Brent Spence Bridge Corridor Project

Ohio Aesthetics Subcommittee

Meeting Summary

January 31, 2023

Steel girder example

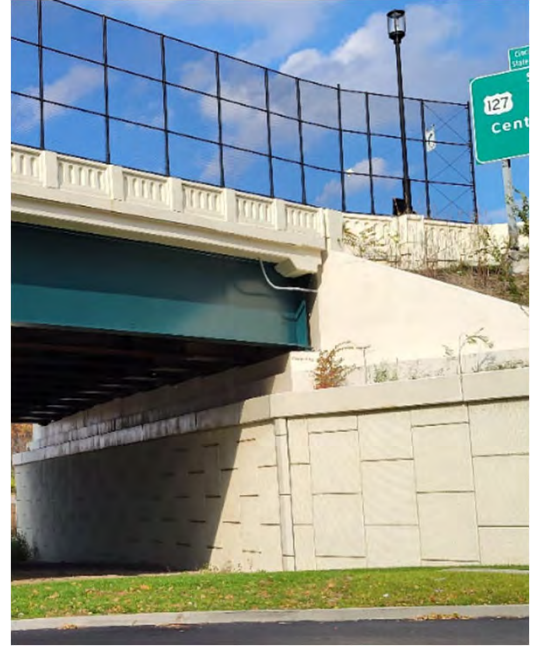
- The planters will have irrigation built into the design.
- Longitudinal and parapet treatments
 - No comments.
- Beams and girder
 - Does the paint color on steel beams under the overpasses have to be the same as Hopple Street? Can ODOT provide a specific color name or number?

- The final decision about color can be made during the design phase and in consultation with the City. Darker colors make inspection more difficult, because it is more difficult to

see cracks. Color options can be explored further once the determination is made about whether the bridges will be steel or concrete.

Lighting Treatments

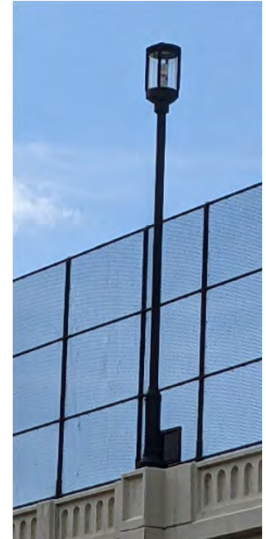
The City of Cincinnati DOTE has one point of clarification regarding lighting. Central Ave. and east of Central Ave. have our "CBD Lighting Standard" which is different than our "Standard Roadway Lighting". This PID includes both types of fixtures. On the checklist Lighting Treatments: Replace CBD and Non-CBD STREET LIGHTING section to:

- Standard roadway lighting: City standard tapered steel pole with bracket arm and LED fixture.
- CBD lighting: East of and including Central Avenue (also includes 3rd Street east of Clay Wade Baily Bridge) as shown in Exhibit A.

Poles, arms, bases, fixtures, and other incidental attachments to street lighting shall be black in color.

The Aesthetic Design Checklist was revised as requested.
